SB-GA8-2012-88

Service Bulletin

Installation of avionics and instruments into a GA8-TC 320 Airvan.

Serial number GA8-TC 320-12-173.

Figure 1 – Mounting Tray Installation

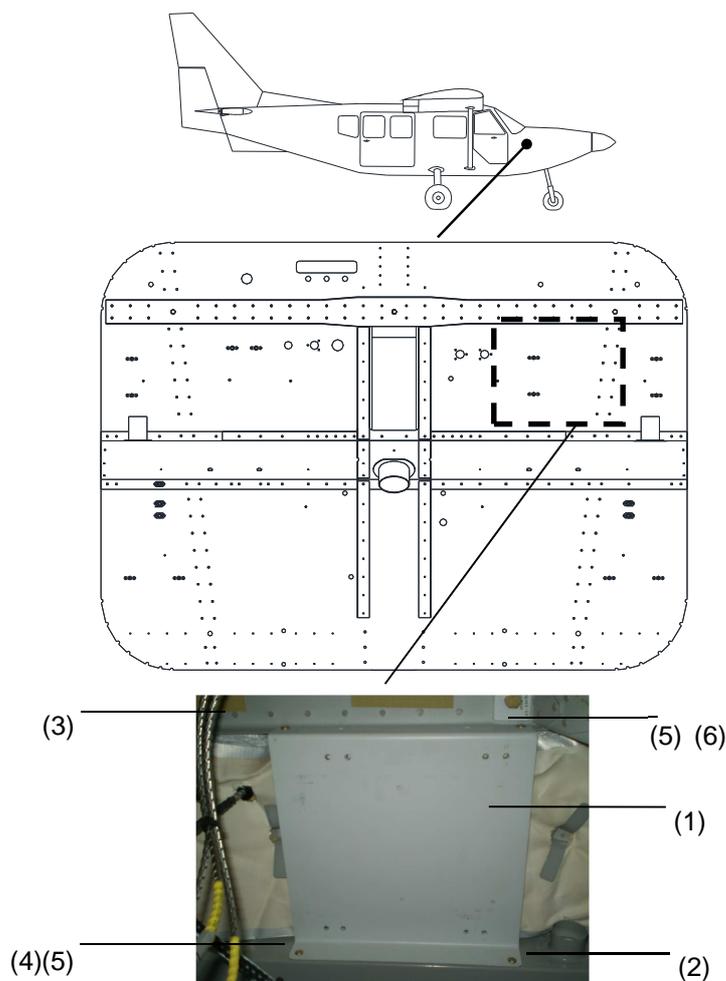
Part 2: Transponder rack

Position the Avionics Mounting Tray GA8-342018-21 (1) on the Firewall in between the Hot Air Duct GA8-713026-27 (2) and the Horizontal Channel GA8-713021-25 (3). Both Figure 1 and Figure 2 shall be used as reference.

Back drill the four holes; two to the Hot Air Duct (2) and two to the Horizontal Channel (3);

Remove the Avionics Mounting Tray and install two Rivnuts NAS1329A08-75 (4) to the Hot Air Duct;

Reposition the Avionics Mounting Tray (1) and secure it with four Screws AN525-832R6 (5) and two Nuts MS21042-08 (6);

Install four Mounting Brackets GA8-342028-33 (7) to the Transponder Stand Alone Rack 115-00629-00 (8) and secure with eight Screws MS24693-S50 (9), Washers AN960L-08 (10) and Nuts MS21047-08 (11);

Slide in and lock the GTX 33 Transponder (12) to the Stand Alone Rack (8);

Position the Stand Alone Rack (8) on the Avionics Mounting Tray (1) and secure it with eight Screws AN525-10R6.
